Docket No. 040-08724
License No. SUB-1357

Your letter of December 23, 1993 to Mr. David R. Sargent forwarded the NRC's comments on our "Site Remediation Plan - Harvard and Bert Avenue Sites" Revision 0, dated October, 1993. Your letter also included comments from Mr. Todd Brady of the Cuyahoga County Board of Health.

CUYAHOGA COUNTY BOARD OF HEALTH COMMENTS
ON
SITE REMEDIATION PLAN CHEMETRON REMEDIATION
HARVARD AND BERT AVENUE SITES

US NUCLEAR REGULATORY COMMISSION
COMMENTS ON CHEMETRON FINAL REMEDIATION PLAN

ATTACHMENT 4

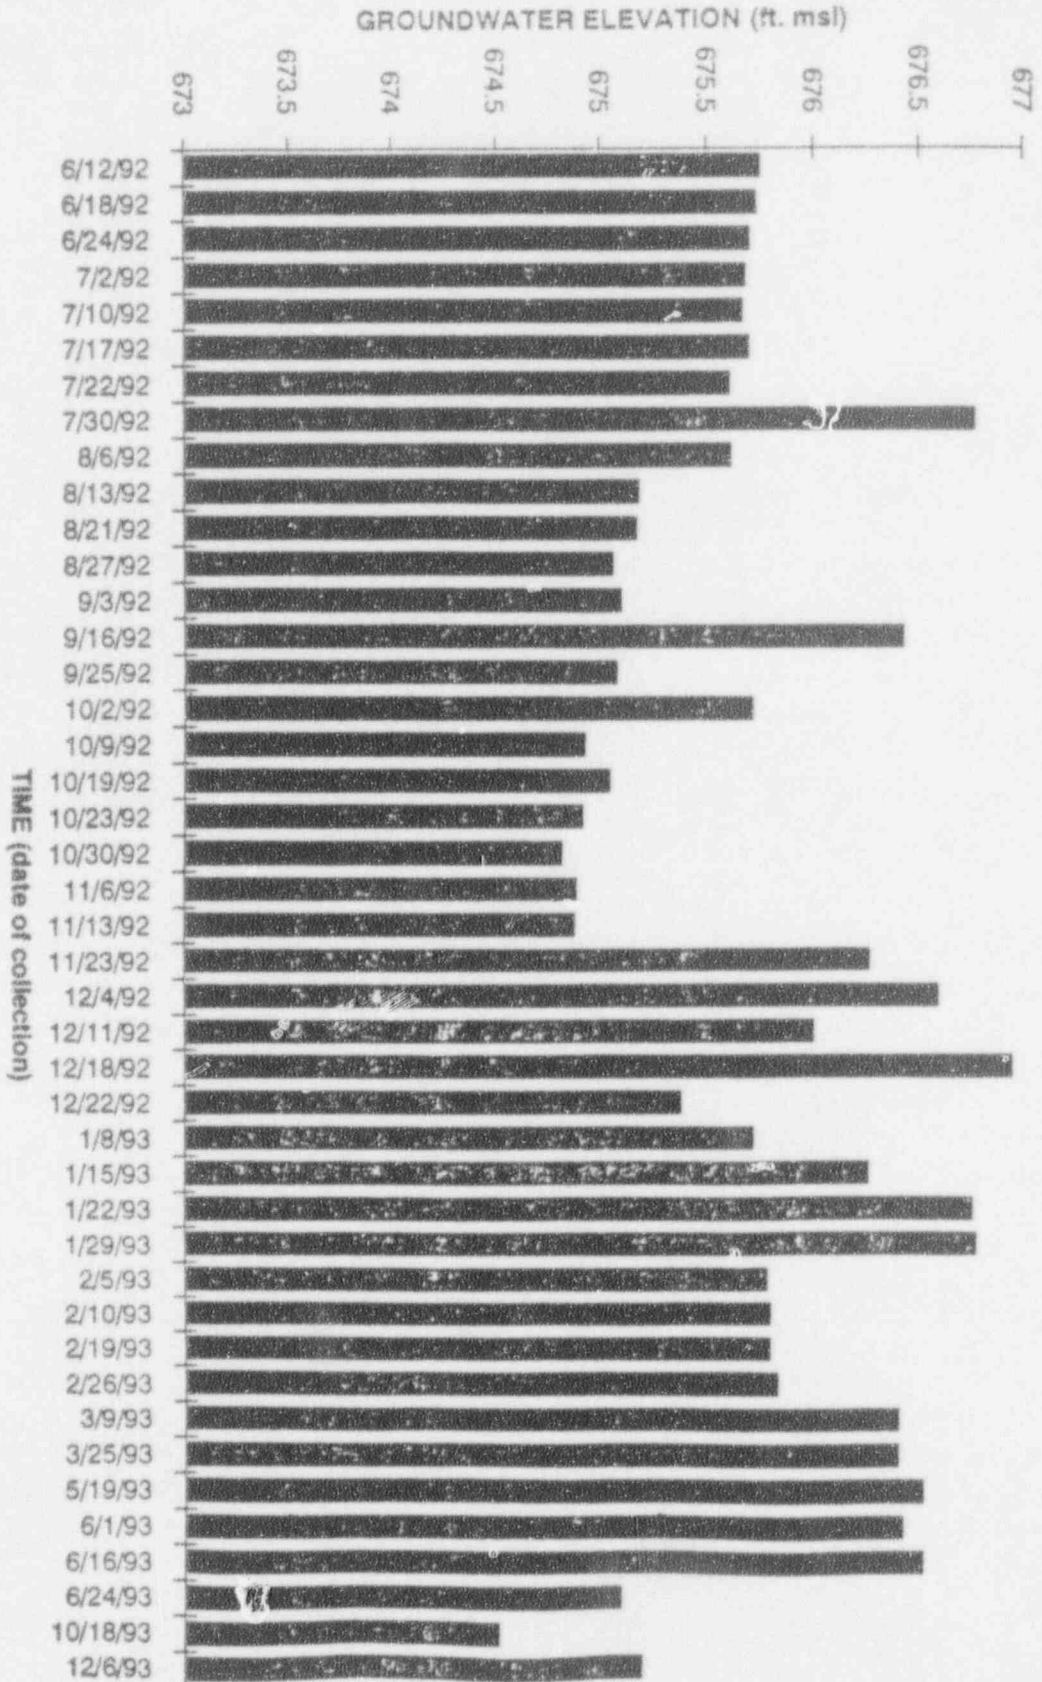
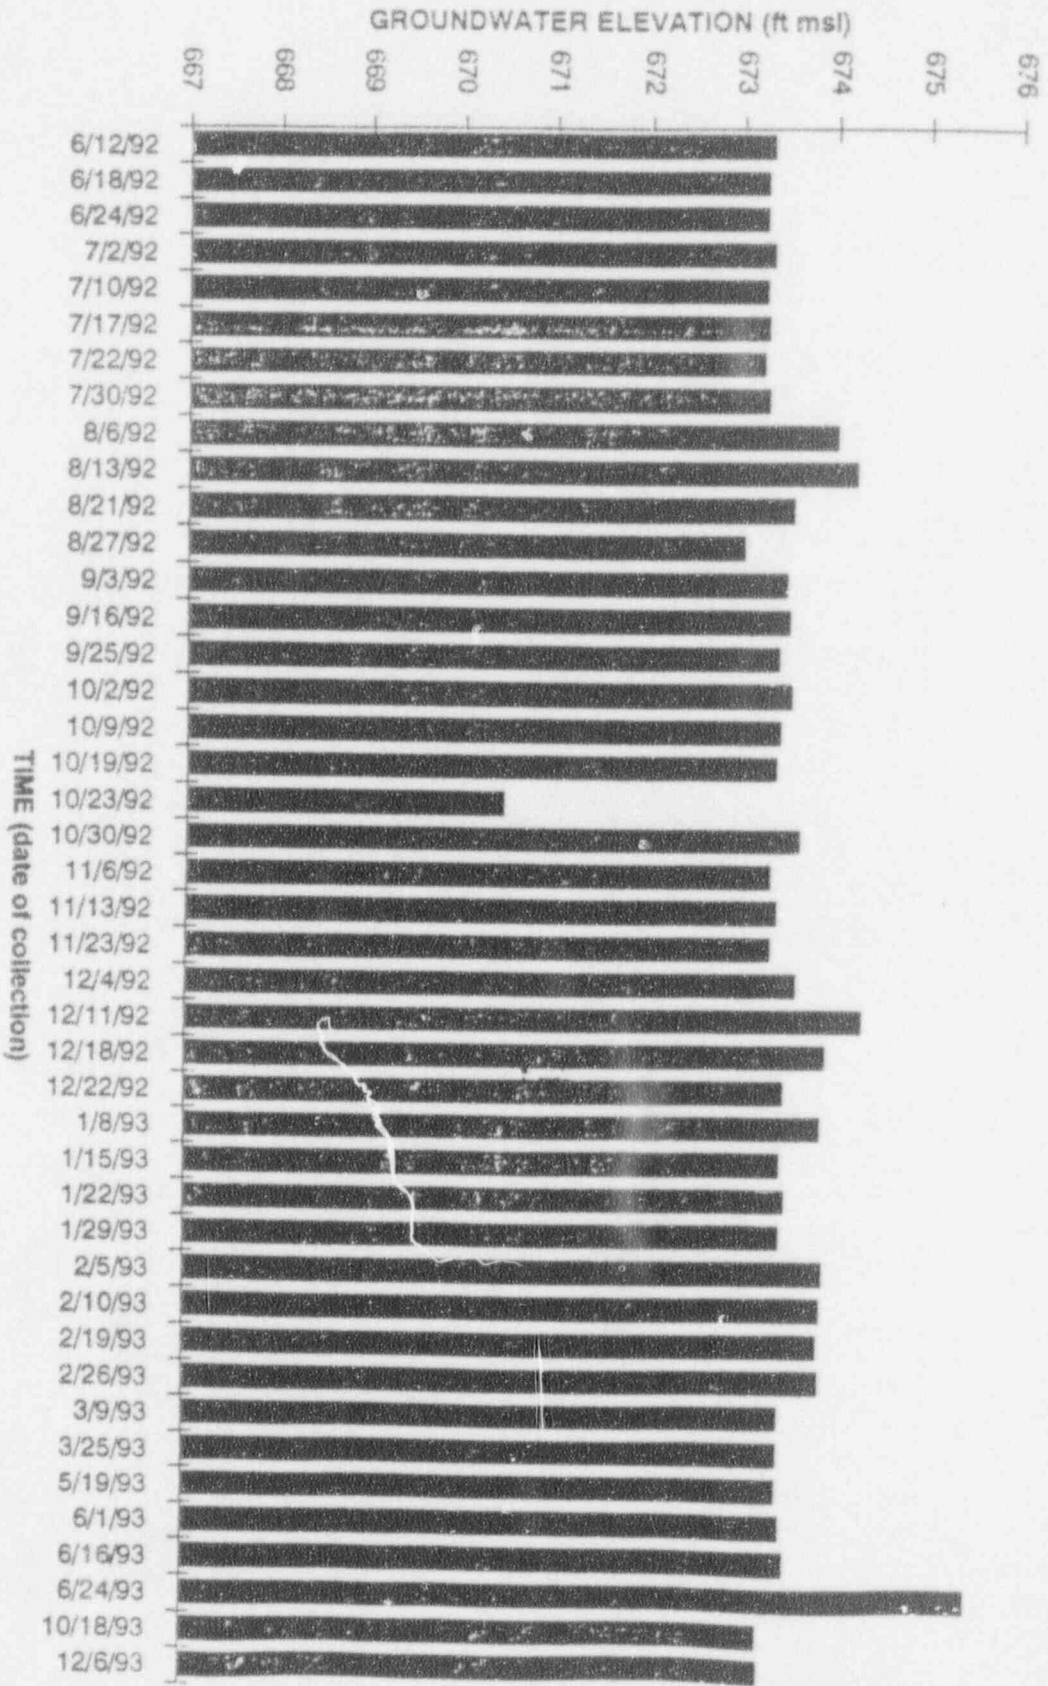
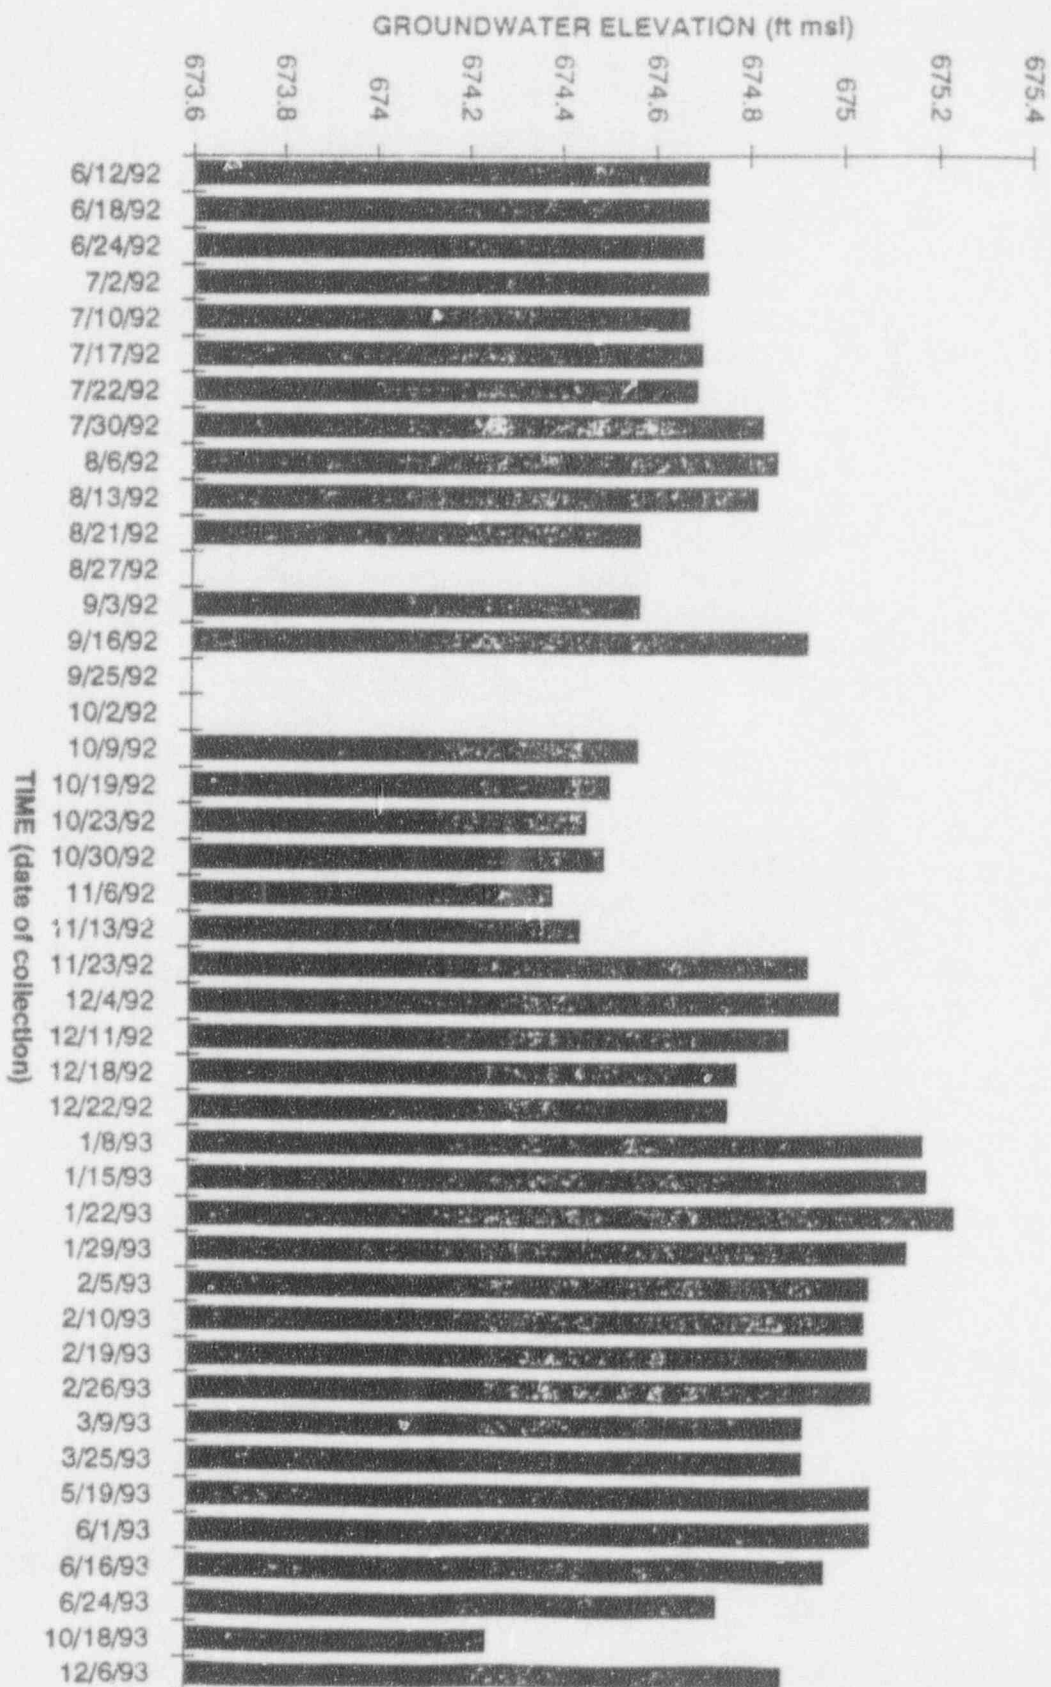
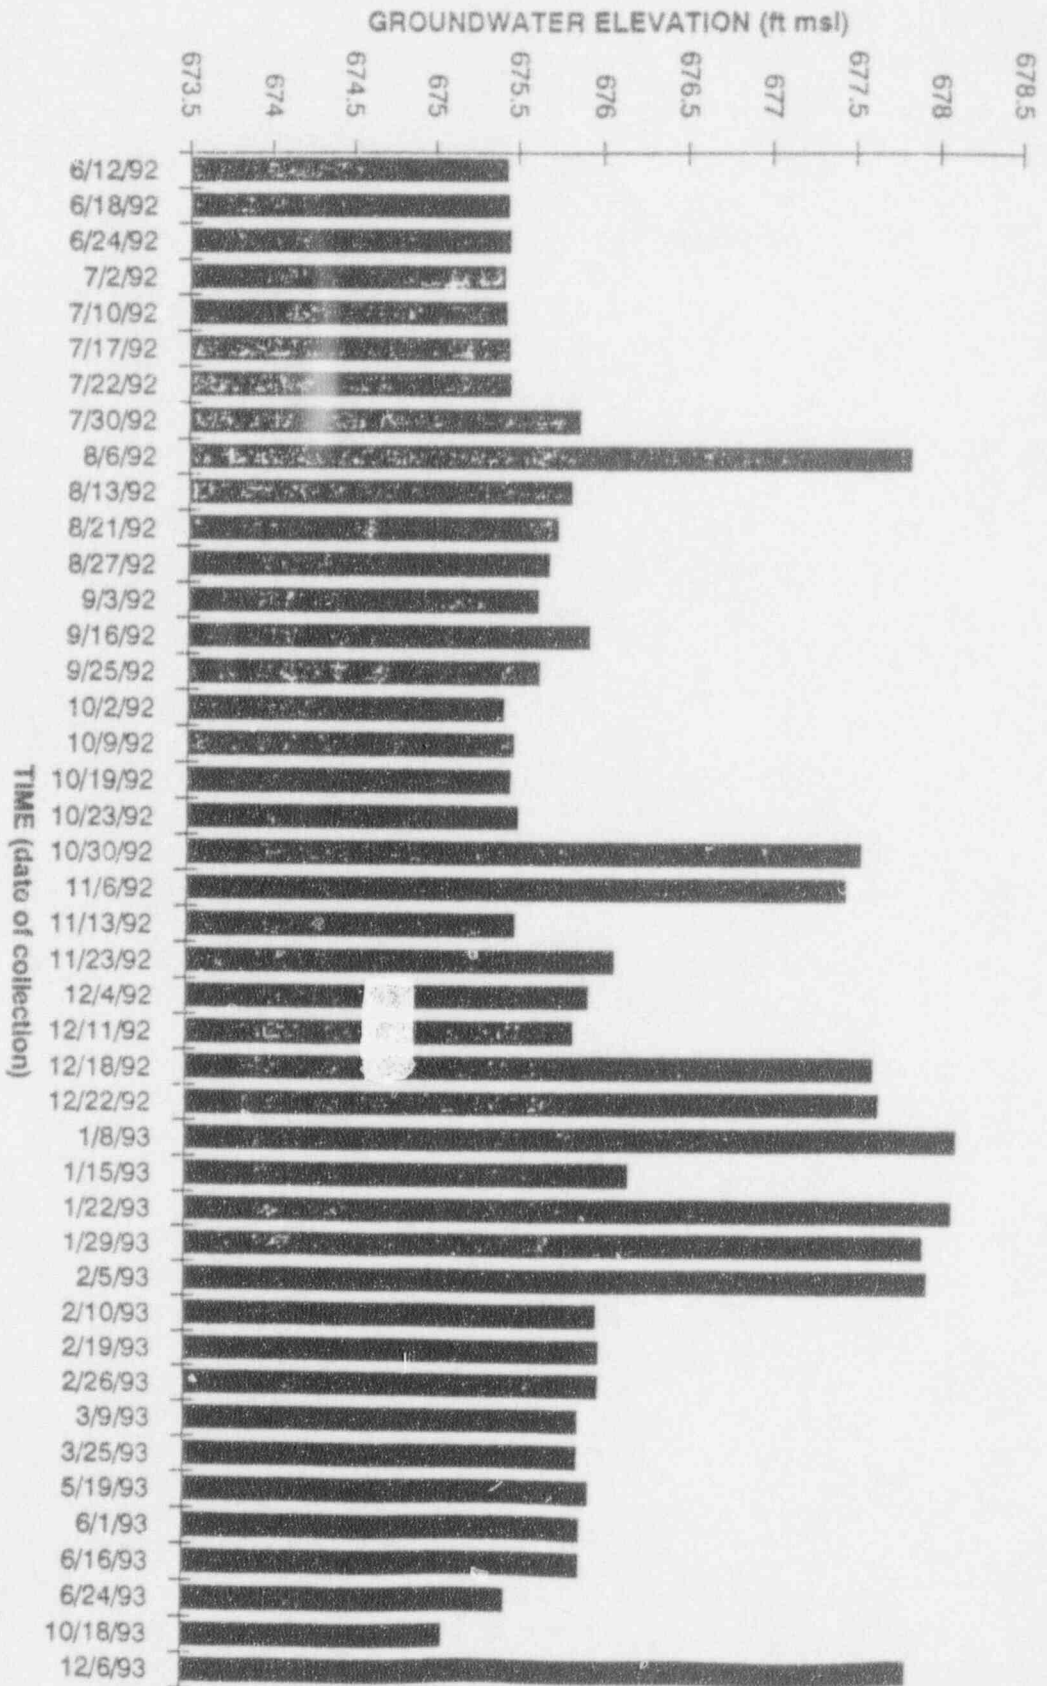
Please provide the groundwater data and hydrographs that support your temporal fluctuation conclusions.

Response: Paragraph 2 presents the groundwater data for Harvard Avenue, and will be revised to specify that point. Groundwater hydrographs are included as Attachment 4 and will be included in the Remediation Plan to present the groundwater elevation trends.
